10/529,154

Office Action Summary

FORCED CONVECTION EVAPORATOR AND WATER CHILLER

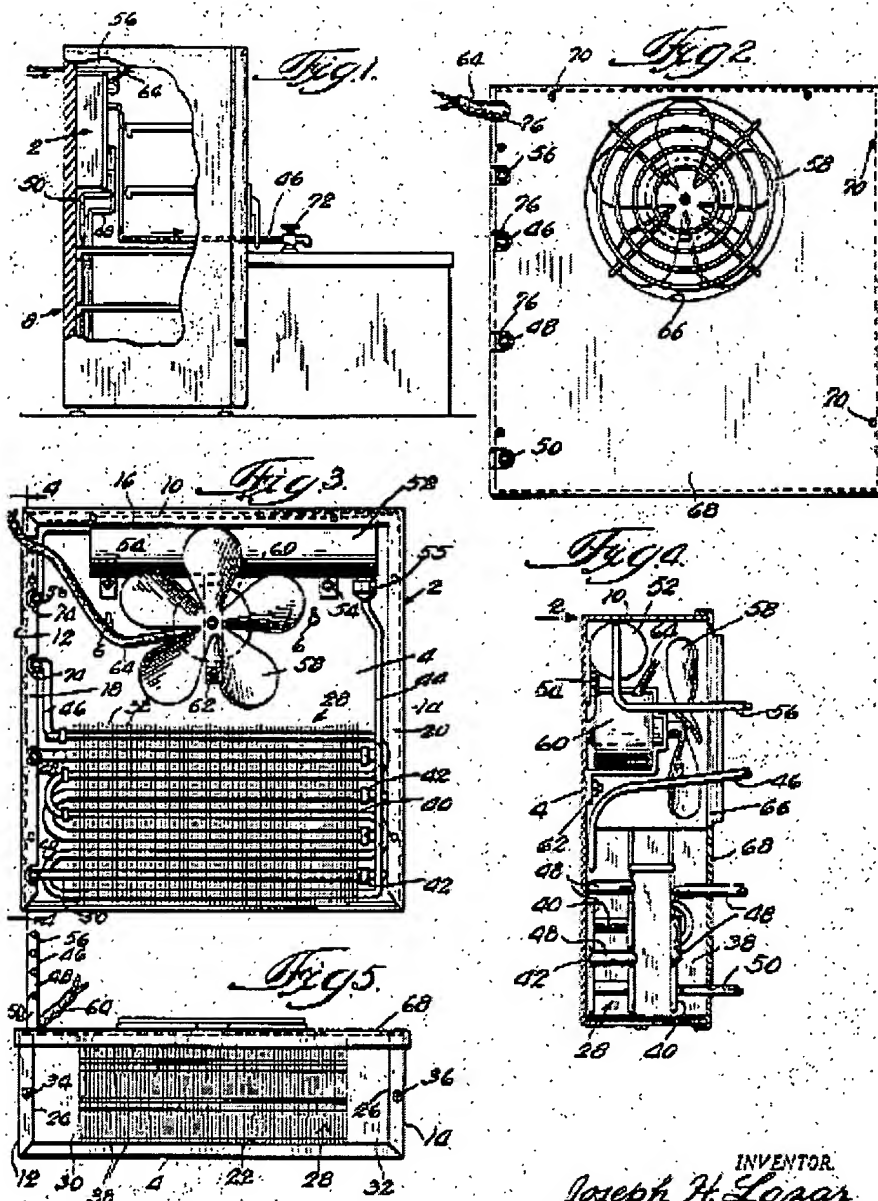
4. In re claim 1, J. H. Lazar discloses the claimed invention:

- ***A cooler provided on at least one side-wall side of a chamber formed with a thermally insulated box (see fig. 4).***
- ***A cooling chamber in front of the cooler (fig. 4).***

- ***A fan that allows air in the cooling chamber to flow (see fig. 2).***
- ***Wherein the cooler and the cooling chamber are partitioned by a partition so as to allow cold air to be accumulated in the cooler (see fig. 4).***

- ***The fan is disposed on a side of a cooler relative to the partition (see fig. 4).***
- ***The partition in front of the fan has an aperture formed in the flat sheet portion (see fig. 2).***

- ***An open space is formed between the fan and the flat sheet portion in which the aperture is formed (see fig. 4).***
- ***Cold air accumulated in a space inside the partition and hot air in the cooling chamber are exchanged by the fan through the aperture (as stated in column 2 lines 42-43 "This circulating system provides efficient refrigeration within the refrigerator 8 ...".***

5. In re to claim 2, J. H. Lazar discloses in fig. 2 that dimensions of the aperture are larger than a diameter of the fan.

6. In re to claim 3, J. H. Lazar discloses in fig. 4 that when viewing the fan in a direction of a rotation shaft of the fan, the fan is disposed in the aperture and there is an open space outside the fan.

7. In re to claim 6, J. H. Lazar discloses in fig. 3, the fan is disposed above the cooler.

8. In re. to claim 8, J. H. Lazar discloses that a slit [opening] is formed in the partition at a portion opposed to the cooler or a portion below the cooler (see fig 5). Since applicant does not teach in specification that "slit" type opening is required, e.g. it's restrictive nature, prior art depicts preferred embodiment with open bottom satisfying claim.

9. In re to claim 10, J. H. Lazar discloses that a safety cover is put over the [fan] aperture using a net or a slit (see fig. 2).

FIG. 1.

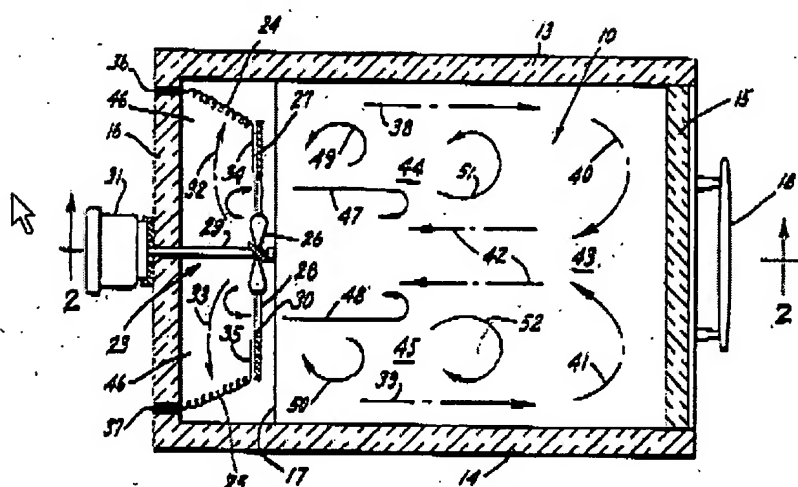
13. Nevertheless, Scofield teaches (fig.1 above) and in column 4, lines 13-27 "[using an oversized fan aperture 28] "..... In normal operation the air of said streams is reasonably hot [cold], although such air may be slightly cooler [warmer] than the air of forward currents 38,39, the thermal gradient being due to inherent and unavoidable radiation of heat from the extended surfaces of flat oven 10 [refrigerator]. It will thus be

seen that returning or short-circuiting airflows 47,48 contribute substantially to the desired affect of additional heating [cooling] to areas 44,45 into which they circulate.

14. In addition, the introduction of such return currents 47, 48 causes added heating [cooling] of said areas 44, 45 and consequently, satisfactory heat equalization between all oven [refrigerated] areas, by the inherent creation of eddies 49, 50, 51, 52 along the boundaries of counter current air flows 47, 38 and 48, 39. Such eddies deflect heated [cooled] air, of maximum [minimum] temperature, from the currents 38, 39 which flow alongside walls 13, 14, and the deflected hot [cold] air is then diffused by such eddies in areas 44, 45. Thus the jet-like and compact form of said hot [cold] air currents 38, 39 is largely destroyed and there is created, in effect, the equivalence of an air guiding and distributing structure, in the area receiving heated [cooled] air, equivalence being provided by the mere employment of oversize fan aperture 28, in the area wherefrom air is supplied by the heaters [coolers]."

15. It would have been obvious to one of ordinary skill in the art at the time of the invention was made to have used an air flow system taught by D. W. Scofield to modify J. H. Lazar in order to create a more subtle temperature gradient in the cooling chamber.

18. In re claim 5, D. W. Scofield (see fig. 1) teaches that using an oversized fan aperture one can create eddy currents to in effect "... deflect heated air ..." as stated in

column 4, line 18, which is analogous to suppressing flow speed of cool air in a cooling system.
